SUBJECT: FIRSTENERGY'S DAVIS-BESSE REPORT

I read your letter dated February 23, 2007, to Mr. Gary R. Leidich at FirstEnergy Nuclear Operating Company (FENOC) regarding the report prepared by Exponent Failure Analysis Associates and Altran Solutions Corporation about reactor vessel head degradation at the Davis-Besse nuclear plant. FENOC submitted the report to the Nuclear Regulatory Commission (NRC), which is available in the NRC's ADAMS online electronic library under ML070860211. I have read the report, too.

Red Rusty Boric Acid Deposits on Vessel Flange (12RFO)

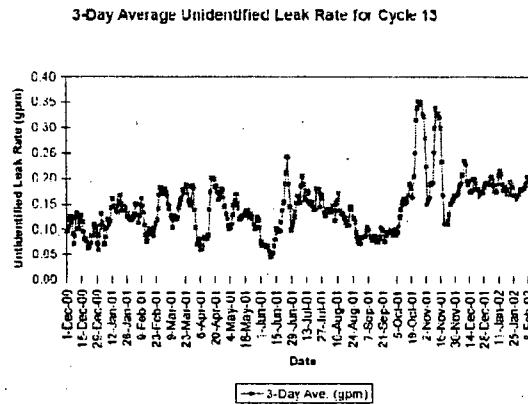
- During 12RFO in April 2000, a worker at Davis-Besse took the infamous "red photo" showing reddish-tinged boric acid crystals flowing down the outside surface of the reactor vessel head from the service platform's weepholes to the flange area. The Exponent / Altran report proposes a small control rod drive mechanism (CRDM) nozzle through-wall leak rate with minor reactor vessel head wastage during 12RFO and no significant leakage or wastage until the crack uncovered in the October - November 2001 timeframe. If so, how does that scenario explain the reality shown in the "red photo"?

Figure 7.2 Three-day average unidentified leak rate for Davis-Besse Cycle 13⁵¹

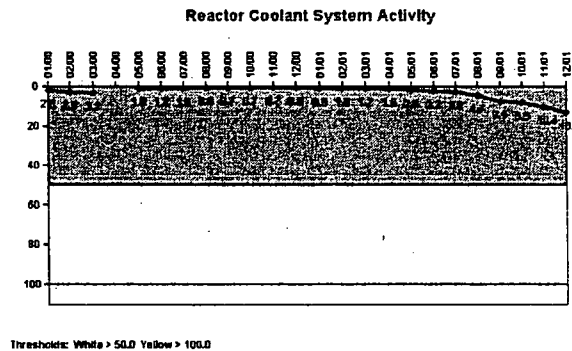
- The Exponent / Altran report relies on circumstantial evidence to support the theory of crack uncovering in the October – November 2001 timeframe. Among the cited evidence is an increase in unidentified leak rate occurring after October 19, 2001. Figure 7.2 from the Exponent / Altran report shows this increase. But the report does not mention or account for the fact that Davis-Besse was shut down on October 19, 2001, and restarted less than a day later due to a generator stator cooling water problem. The thermal cycling associated with shutting down and restarting a nuclear power plant could easily explain a discernible yet minor increase in the unidentified leakage rate.
